Project Name:	Factory 52 - Market Hall - Innovation Hub	Submittal Code:	233423.00-PD-01	REV:	00
Document Set:	Bid/Construction				
KLH Project #:	22552.01-Bid	Received Date:	02/11/2022		
Section Name:	HVAC Power Ventilators				
Section Number:	233423.00				
Submitted By:	HGC Construction Co.				
Authored By:	Cincinnati Air Conditioning				
Client Name:	MSA Design

Submittal #233423-23A.26.1 - F52: Food Innovation Hub - HVAC Power Ventilators - SD 233423 - HVAC Power Ventilators

Architect: MSA Design
Engineer: KLH Engineering
HVAC: Cincinnati Air Conditioning
Item: Power Ventilators, PER BULLETIN #1 (EF #1 ONLY)
Spec. # 233423

Model: G-120-B

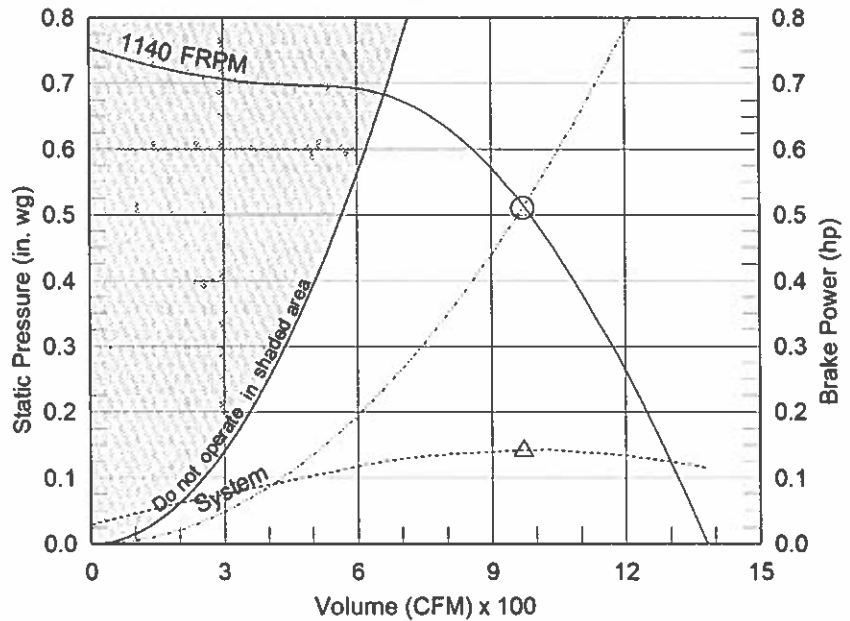
EF-1

- 1.1 No exceptions to submitted Greenheck fan G-120-B.
- 1.2 No exceptions to accessories including VCD control damper and roof curb.
